CONSTRUCTION PHOTOS OF EUT
Configuration A

Configuration B

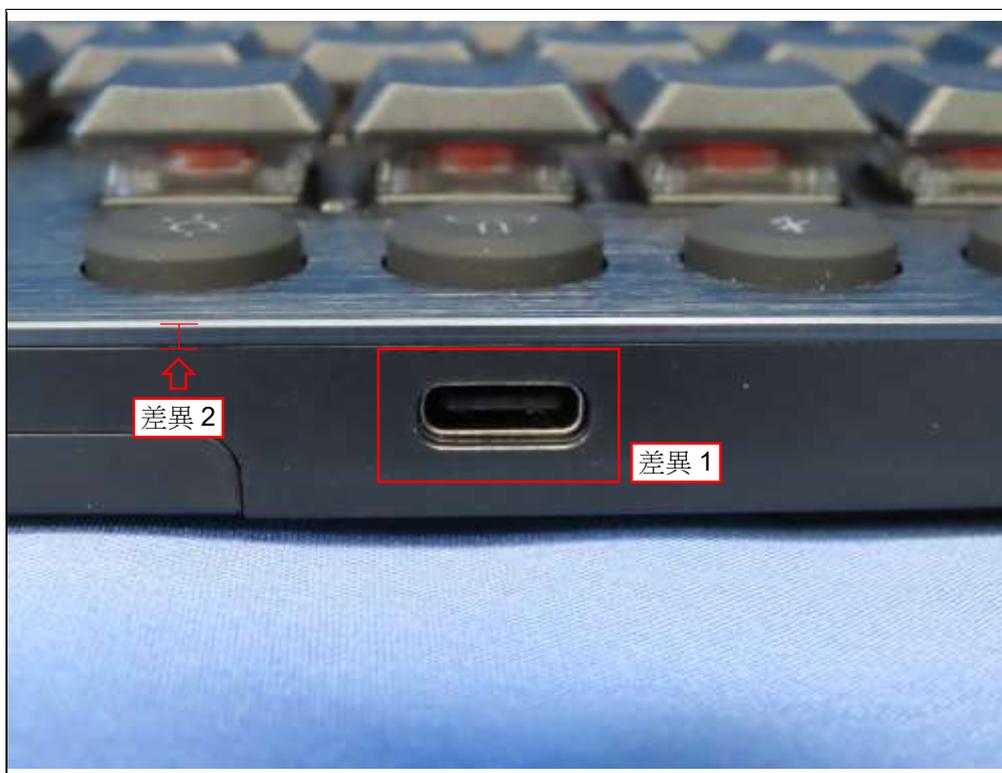
與原始差異 1 (Power connector change from Micro B to Type C)

與原始差異 2 (metal top case thickness from 1.2 mm to 1.5 mm (east-west KB+ 0.6 mm, height + 0.3 mm)

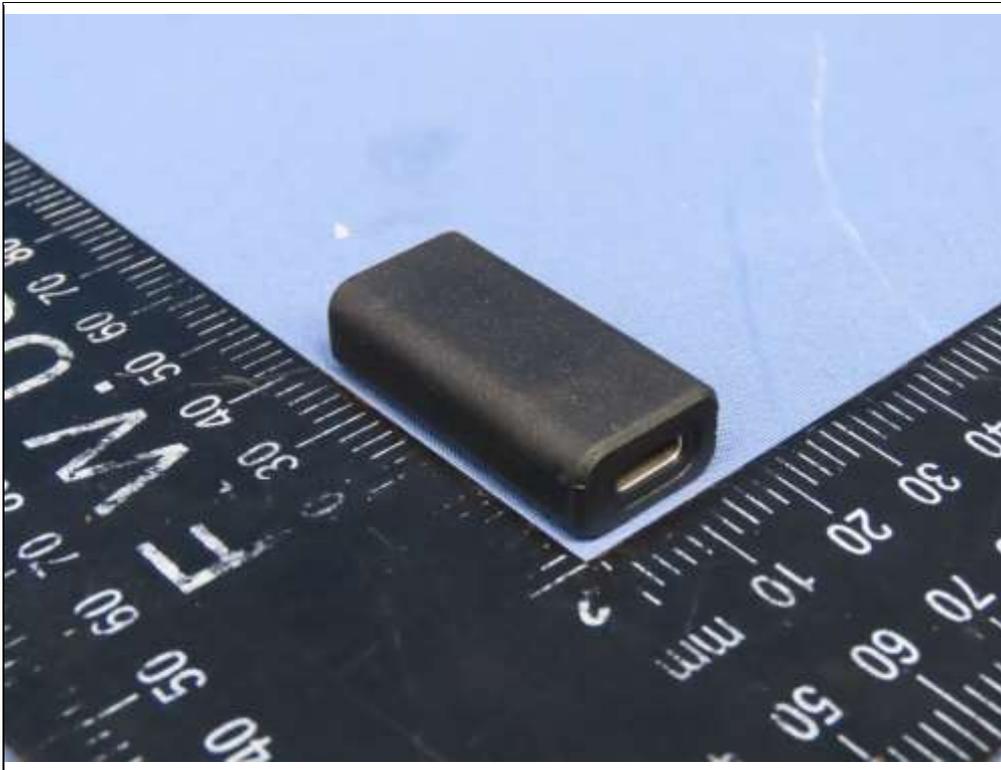
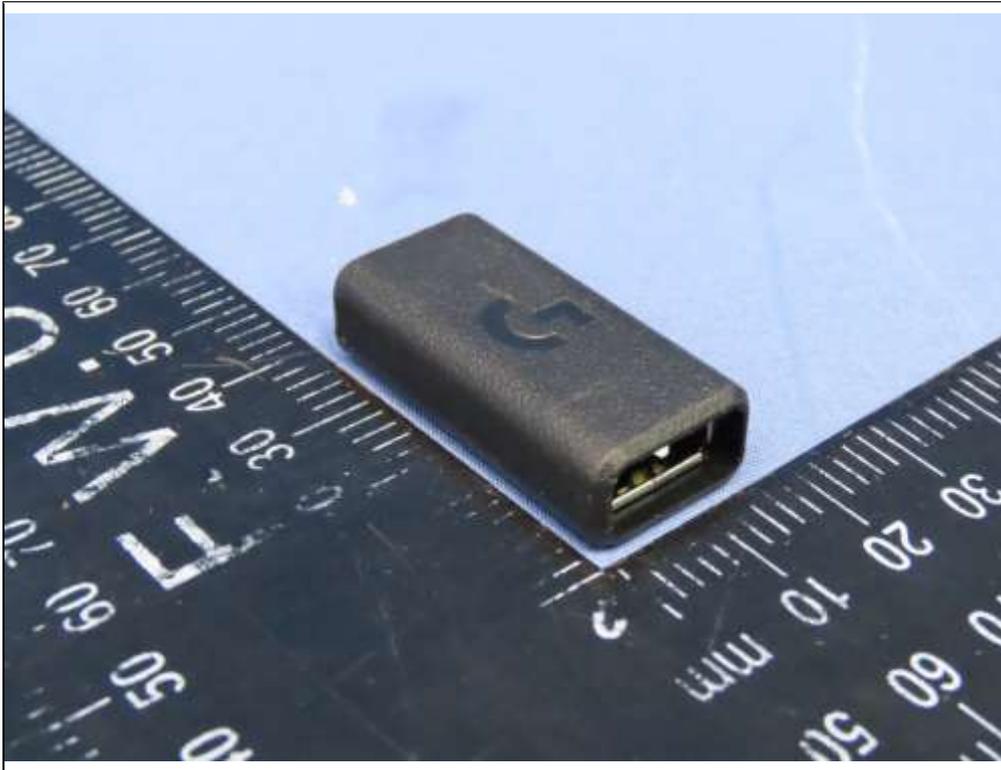
Original (USB to Micro USB cable)

Newly (USB-A to USB-C cable_black)

Newly (USB Extender _black)
